**Eastonville Road – Londonderry Dr. to Rex Rd.
Segment 2 Improvements
Stationing 47+00.00 – 79+31.62**

Final Drainage Report

August 2024

CDR2321

Box ID: **Geick Ranch Tributary 1 Box Culvert**

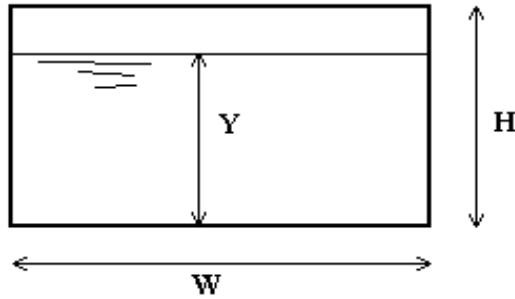
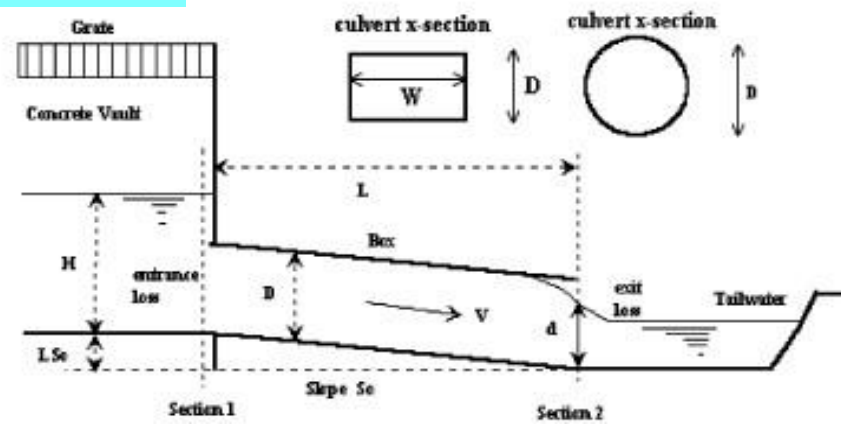
Map calls out 3.5' height. Please verify and update spreadsheets/plans accordingly

EASTONVILLE 16 - 100-YR TAILWATER CONDITION

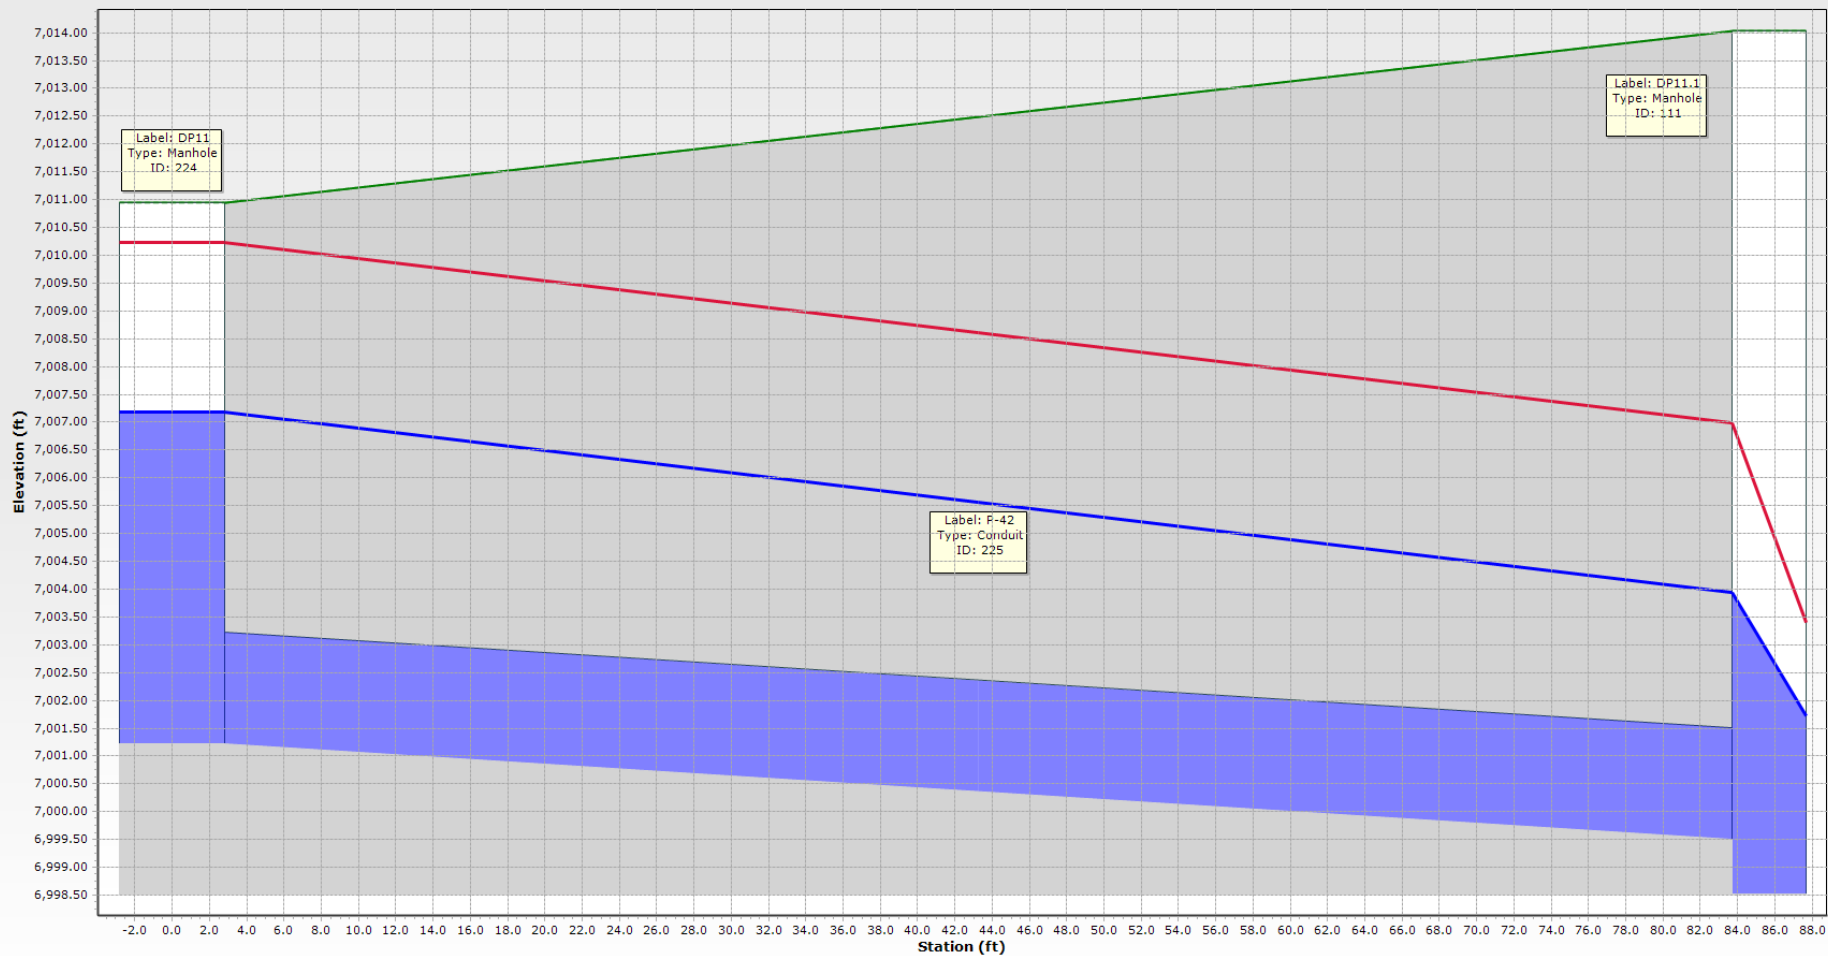
Unresolved:
Inlet is flooding. Please
revise design to ensure
HGL is 1 ft below grade.

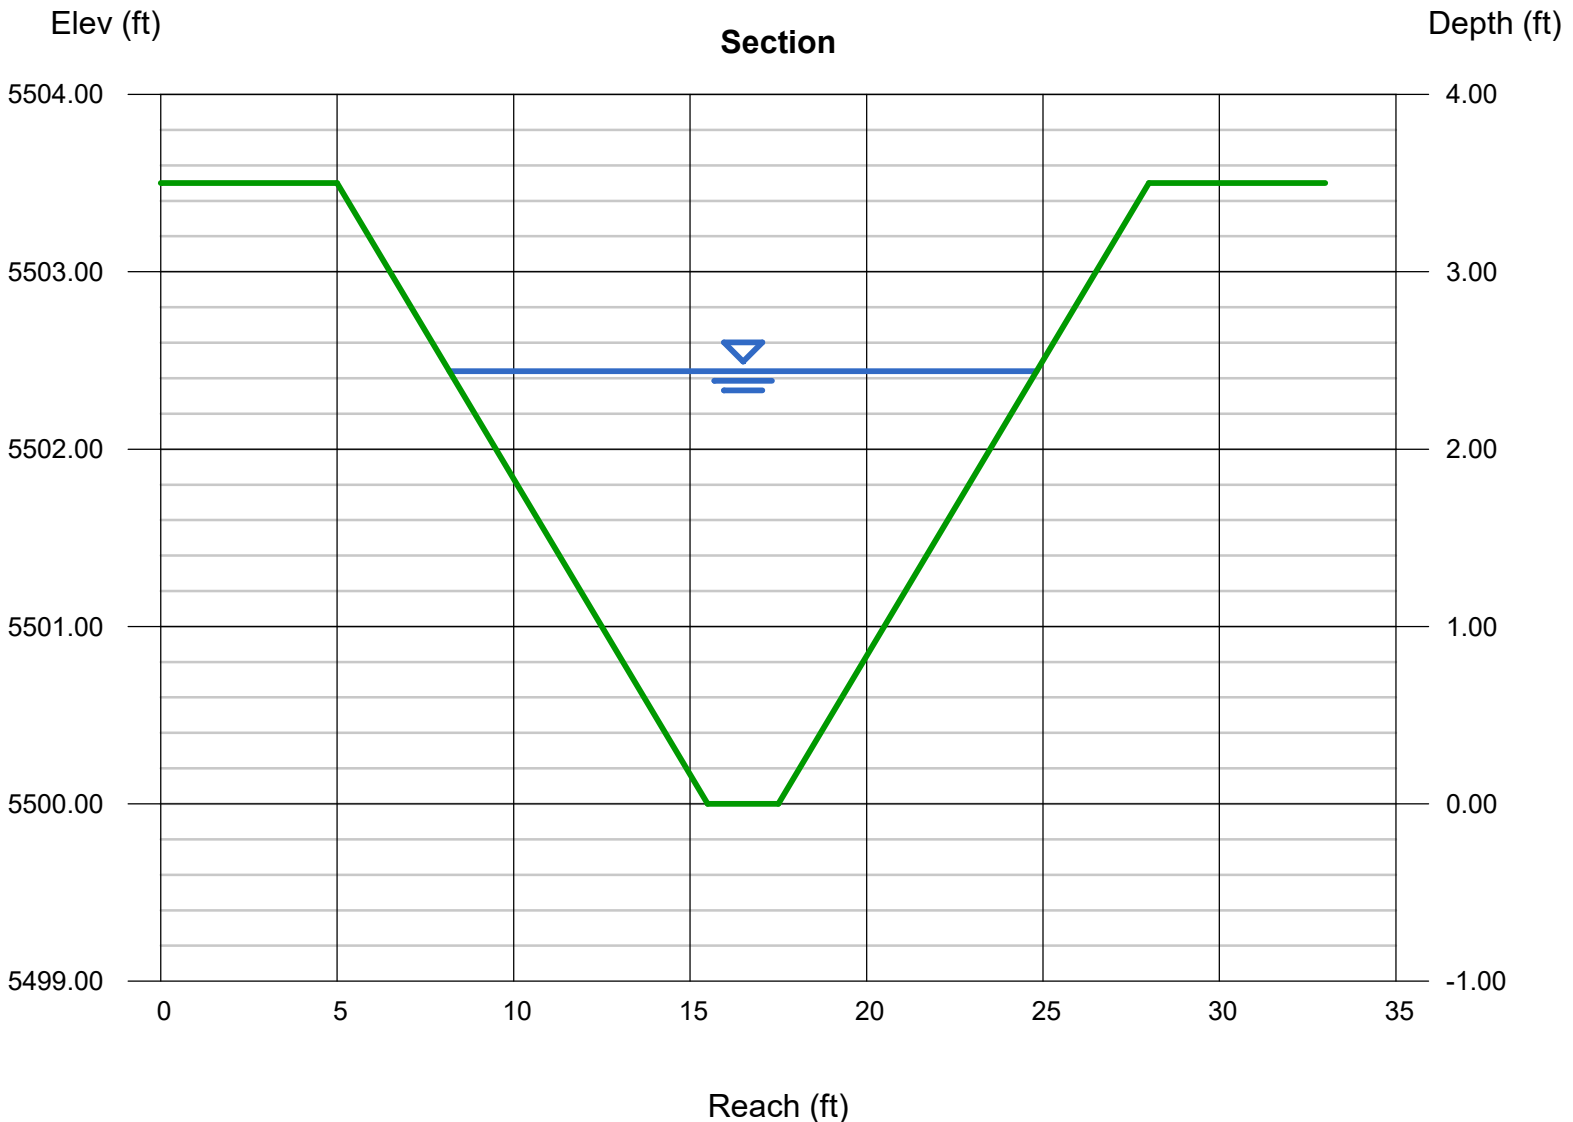
Provide Fr # for this swale

Basin ID: POND B: Ultimate Conditions (INCLUDES SEGMENT 2 FLOW) [BASINS EA6 - EA10]

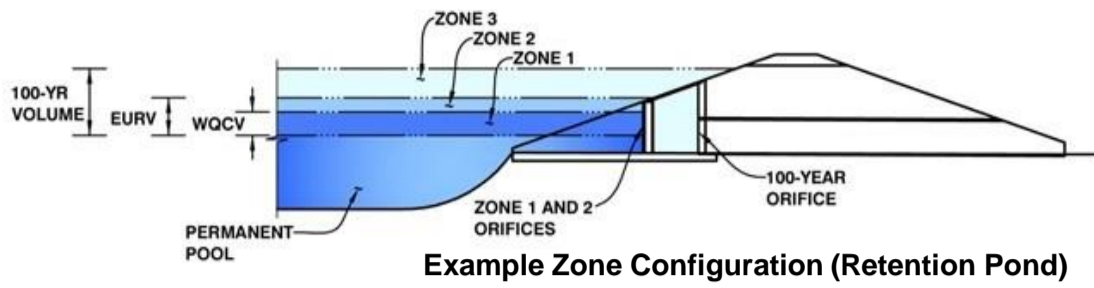
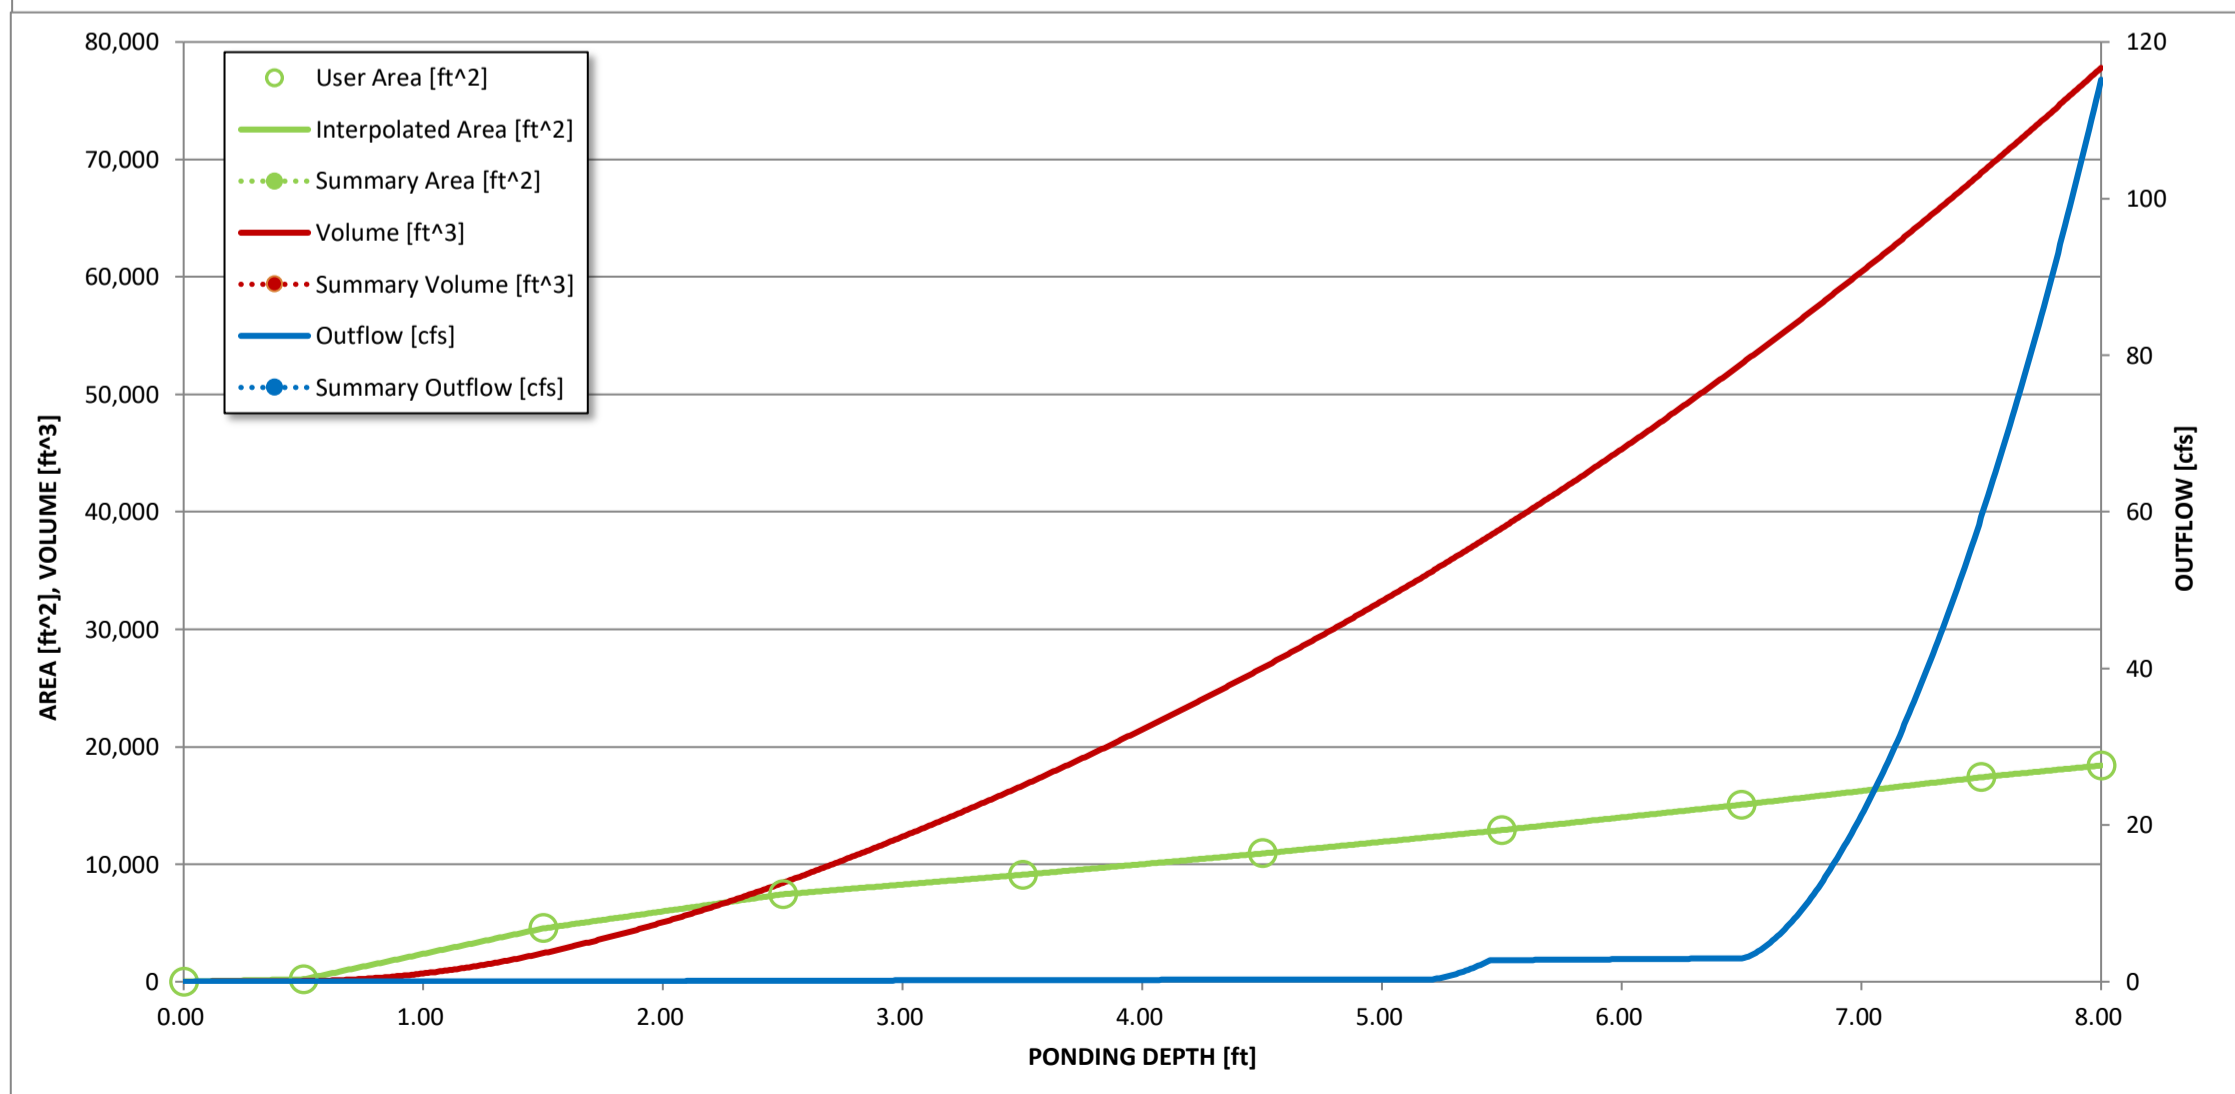
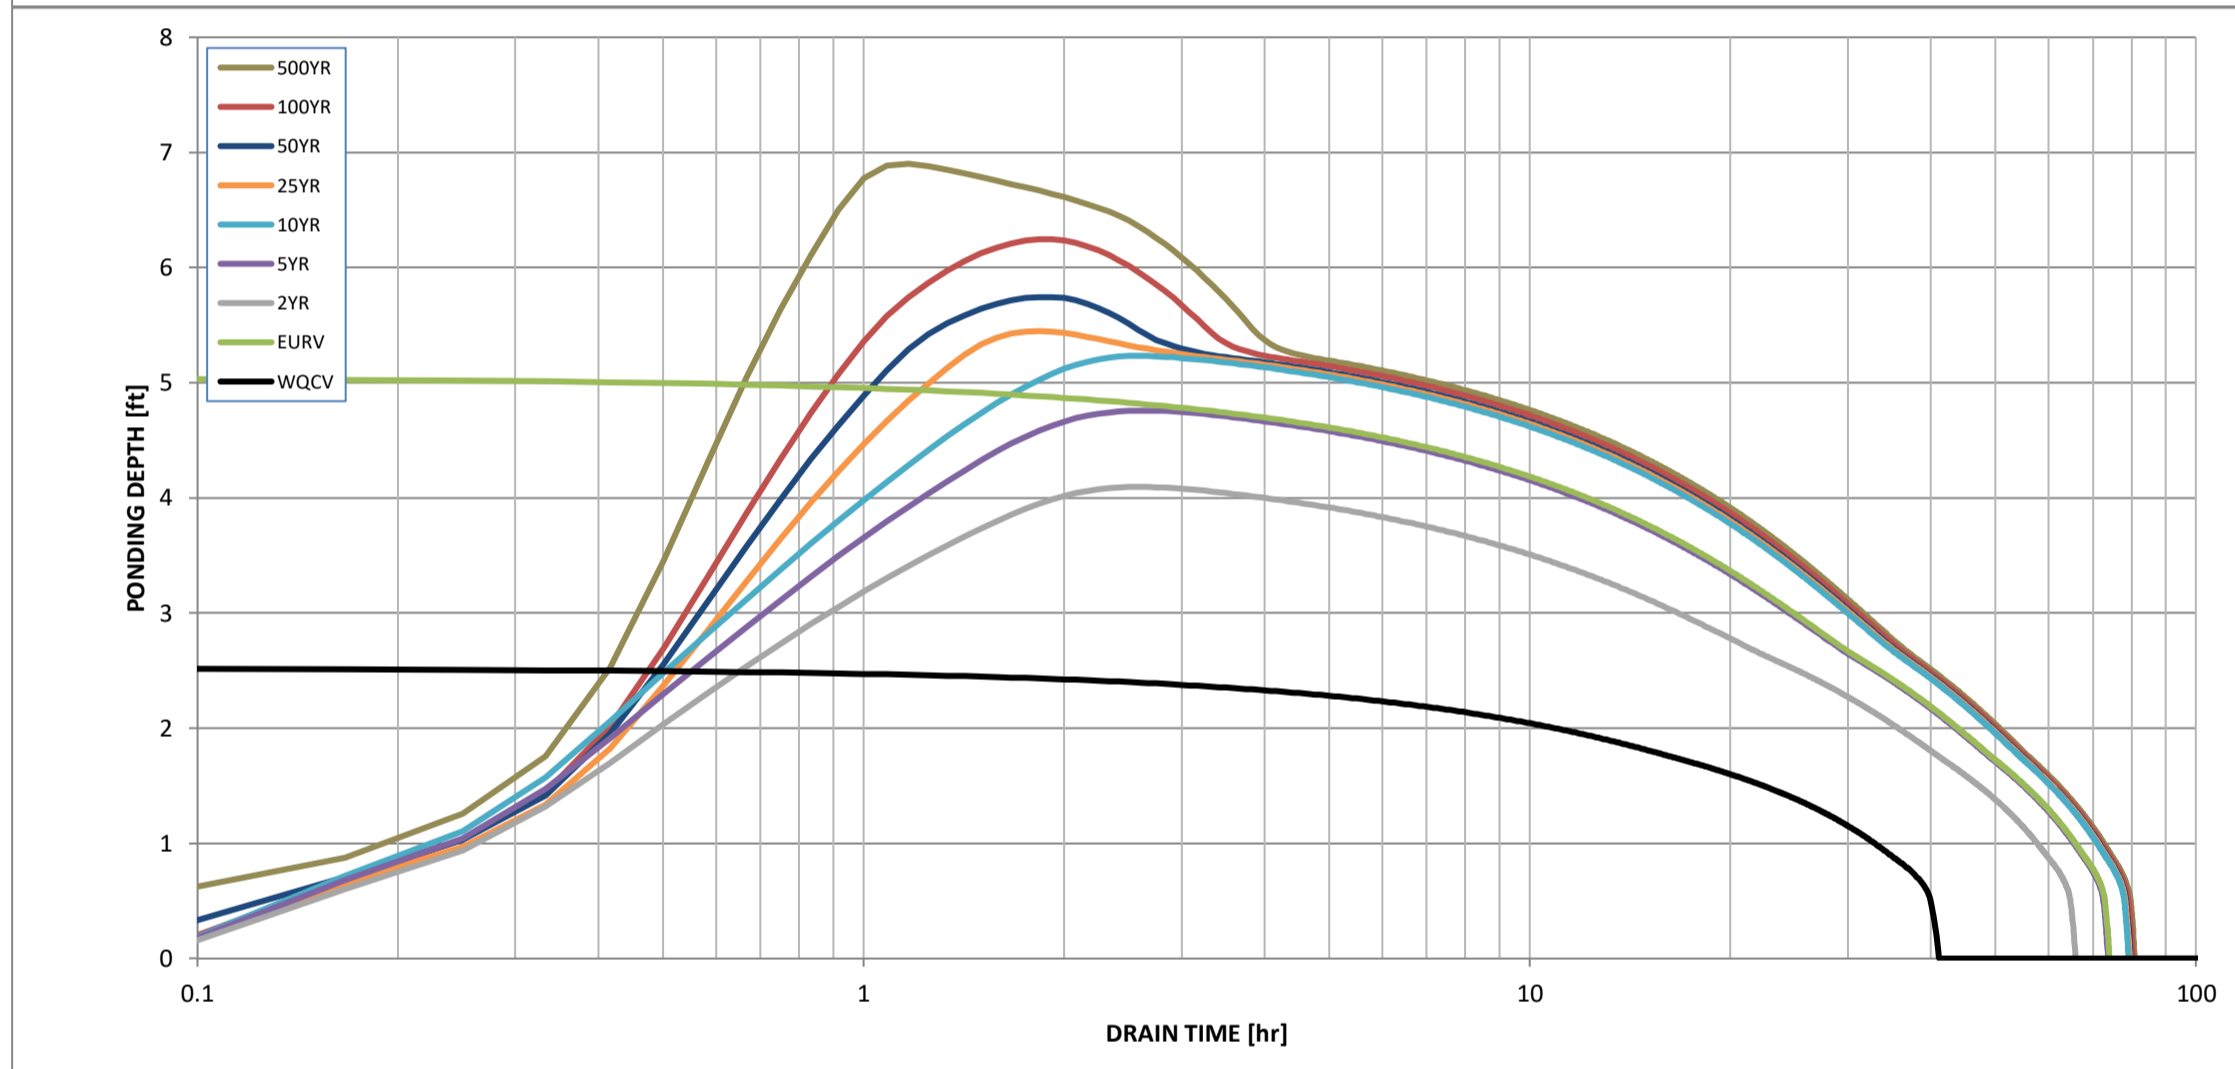
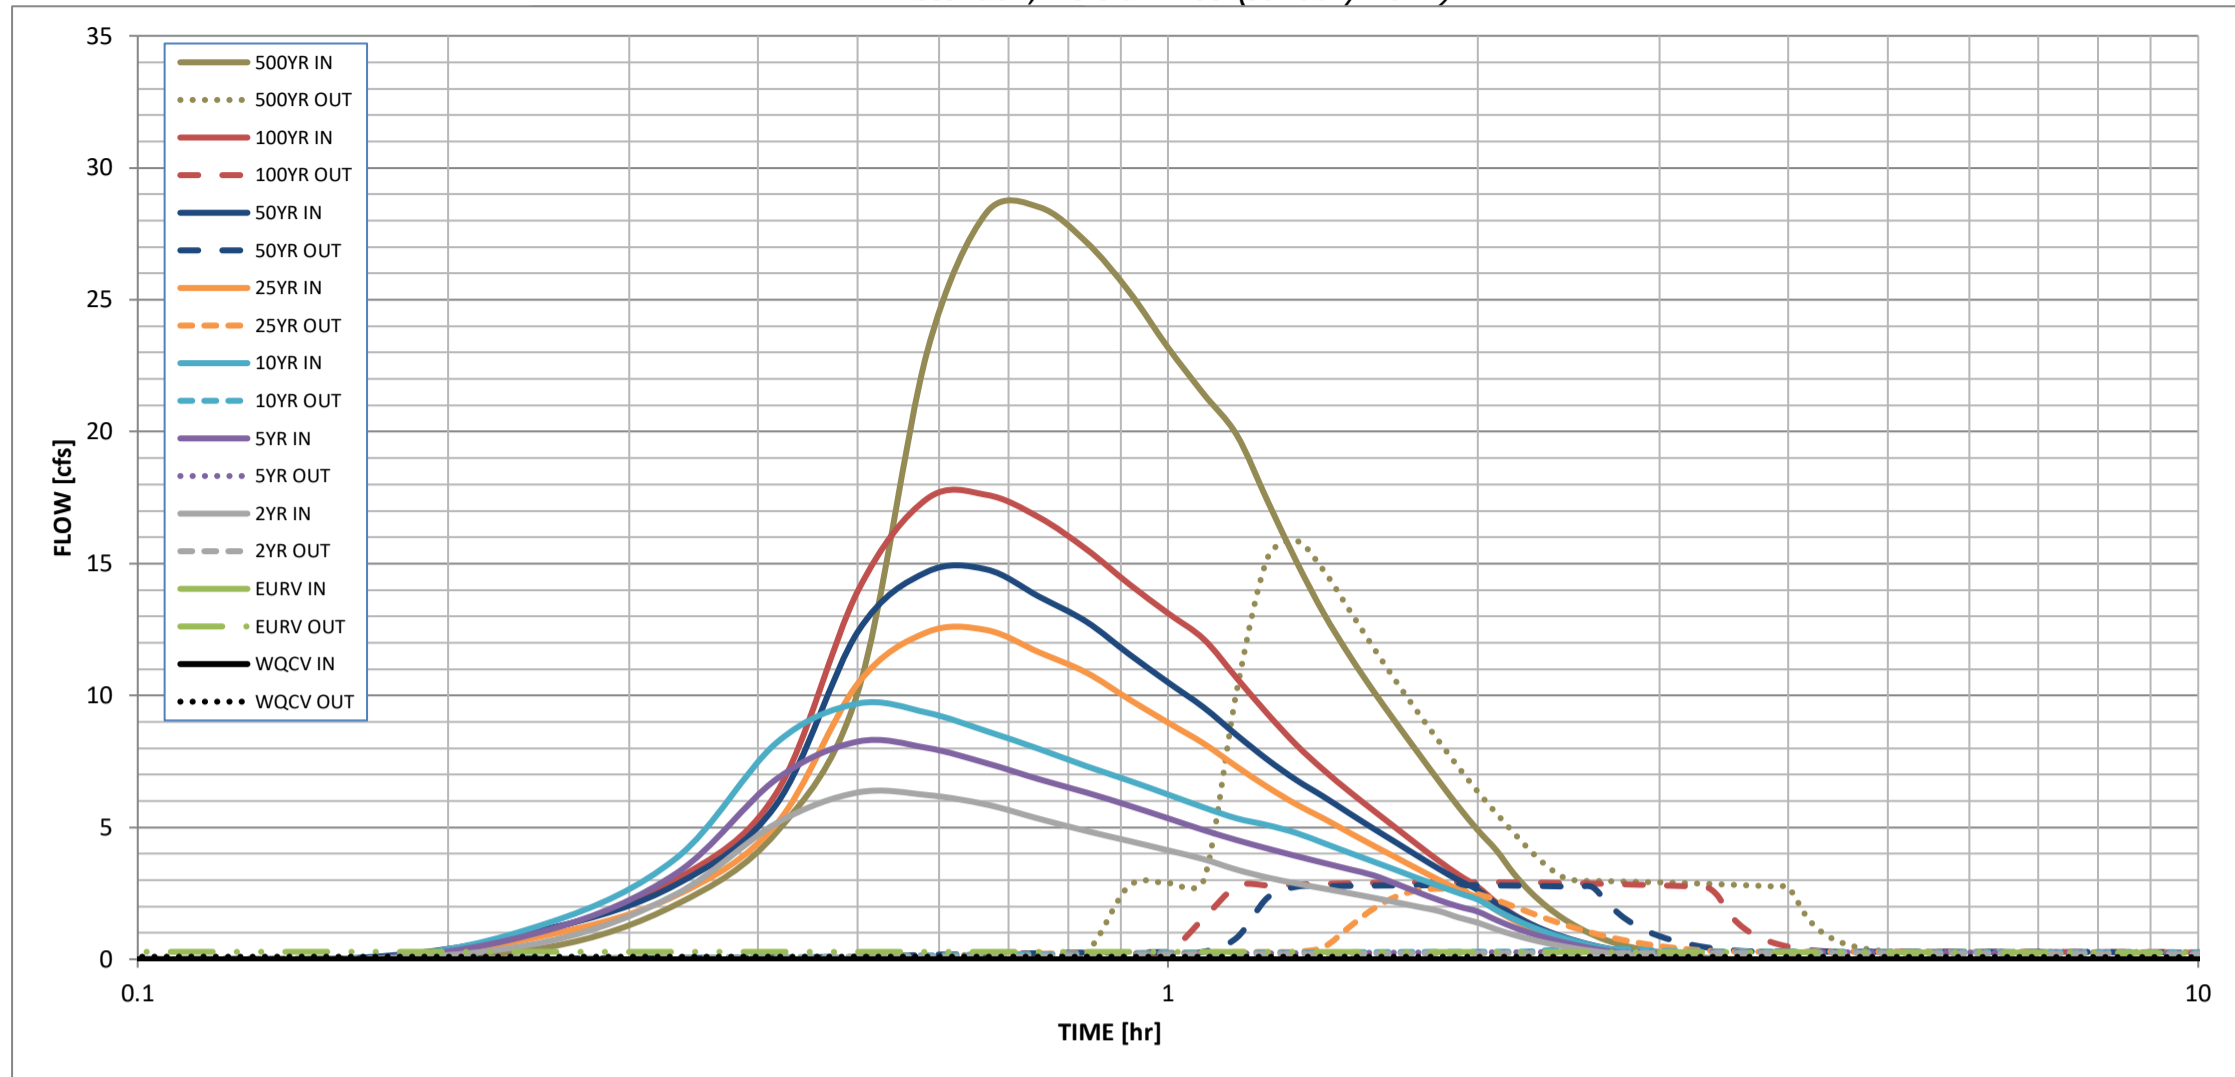
When are the details for this Ultimate Condition going to be designed/submitted? Because I do not see them with the Segment 2 CDs.

Please provide them so that I can review these calcs.
